Buzzing Noise From LH Side Under Dash

Service Category Vehicle Interior

Section Heating/Air Conditioning

Figure 1.

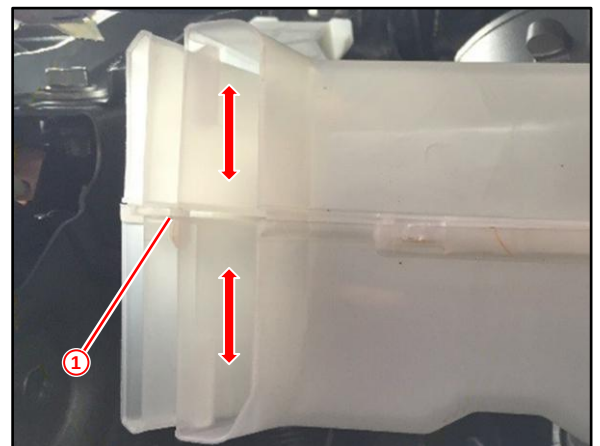
Some 2016 model year Prius vehicles may exhibit a condition where there is a buzzing noise from the LH side under the dash while driving (see Figure 1).
